NFPA 72®-2019 Edition

National Fire Alarm and Signaling Code®

TIA Log No.: 1410

Reference: 2.3.2, I.1.2.2 and various others

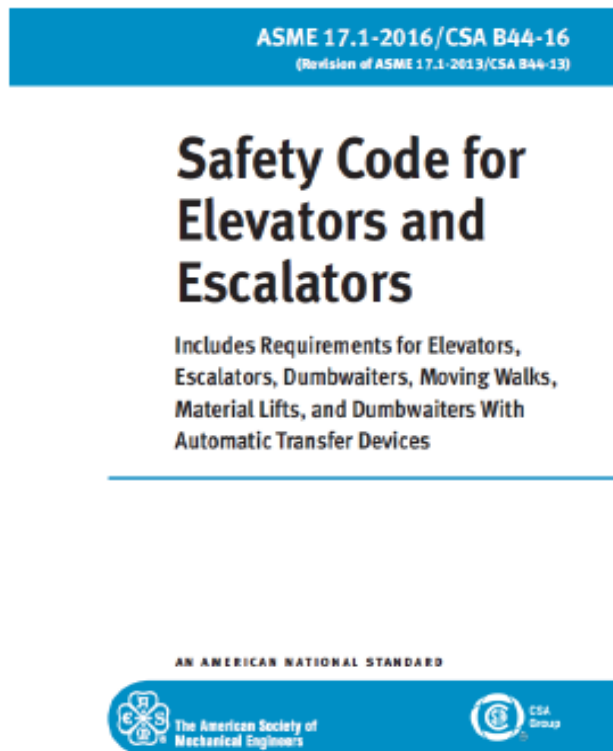
Mr. David McColl – Chair of the A17.1 Emergency Operation Committee states that the Correct Reference in NFPA 72-2019 Sections 2.3.2 and I.1.2.2 should be: ASME A17.1-2016/CSA B44-

16, *Safety Code for Elevators and Escalators*; and references a screenshot of the current 2016 cover page below.
